Administrative Approval Action

Case File / Name: ASR-SR-111-2018
The Cypress of Raleigh Phase 3 - Villa E

REQUEST: Development of a 44.01-acre tract zoned PD (Z-16-16/MP-1-16) to add a 116,095 sqft apartment building for additional dwelling units in Group Living.

OVERALL
LANDSCAPE PLAN

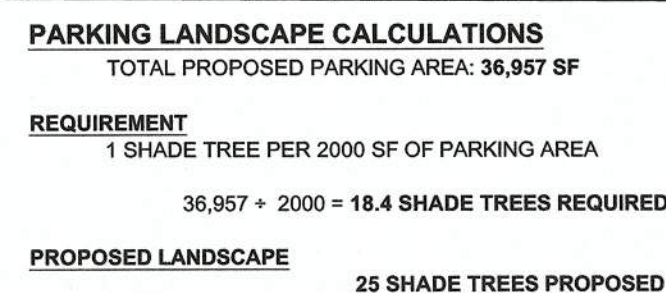
Revision: Initially, the preliminary site plan (ASR-111-18) was approved showing street trees along Harvest Oaks Drive and Forum Drive .

The Master Plan (MP-1-16), specifically 6.A paragraph 2, adopted the existing conditions along Forum Drive and Harvest Oaks Drive as alternate street sections, thus no additional infrastructure, including street tree plantings, are required as part of this development plan.

As a result, this revision reflects the removal of street trees along Harvest Oaks Drive and Forum Drive from the landscape plan which is in accordance with MP-1-16.
